Access Compliance Report

Public Rights-of-Way

(Curb Ramps)

Intersection ID: 10018539	Main Street: FOREST_POND_DR	Cross Street: N/A	Location: S
ADA ID: 80A57605AD47	Ramp Type: Perp	Initial Pass/Fail: Fail	Overall Compliance: No
Severity Score: 22.5			
Codes/Mitigation Info/Possible Solution		Field Measurements/Component Compliance

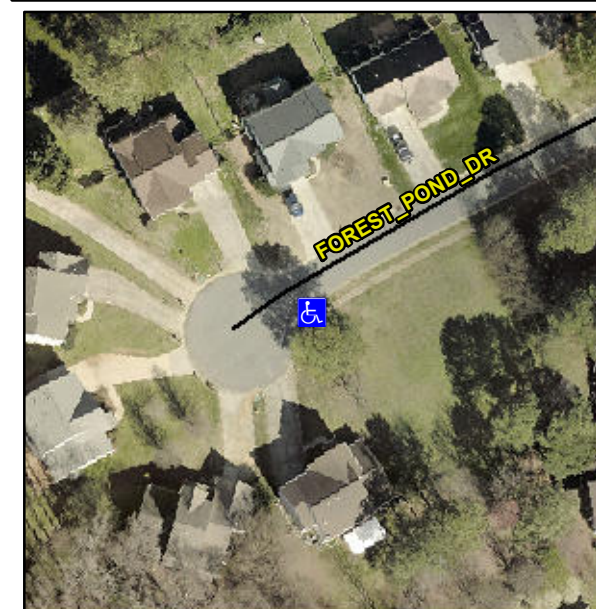
Not Found, R304.5.1, R304.2.2

Compliance	Description	Data	Compliance	Description	Data
N/A	Ramp Length (in)	97.0	No	Ramp Slope (%)	10.8
No	Ramp Width (in)	47.0	Yes	Ramp XSlope (%)	3.7
N/A	Flare Type LT	N/A	N/A	Flare Type RT	N/A
N/A	Flare Slope LT (%)	N/A	N/A	Flare Slope RT (%)	N/A
N/A	Flare Traversable LT?	N/A	N/A	Flare Traversable RT?	N/A
N/A	Landing Length (in)	N/A	N/A	DWS Provided?	N/A
N/A	Landing Width (in)	N/A	N/A	DWS Contrast?	N/A
N/A	Landing Slope (%)	N/A	N/A	DWS Length (in)	N/A
N/A	Landing X Slope (%)	N/A	N/A	DWS Full Width?	N/A
N/A	Landing Curb? (Y/N)	N/A	N/A	DWS Offset (in)	N/A
N/A	Shared Landing?	N/A			
N/A	Gutter Ponding?	N/A	N/A	Gutter Slope (%)	N/A
N/A	Gutter Lip Ht (in)	N/A	N/A	Gutter X Slope (%)	N/A
N/A	Painted X Walk1?	No	N/A	Painted X Walk2?	N/A
	X Walk 1 Direction	To N		X Walk 2 Direction	N/A
N/A	X Walk 1 Width (in)	N/A	N/A	X Walk 2 Width (in)	N/A
	X Walk 1 Slope (%)	3.6		X Walk 2 Slope (%)	N/A
	X Walk 1 X Slope (%)	4.6		X Walk 2 X Slope (%)	N/A

Remove & Replace Entire Ramp.
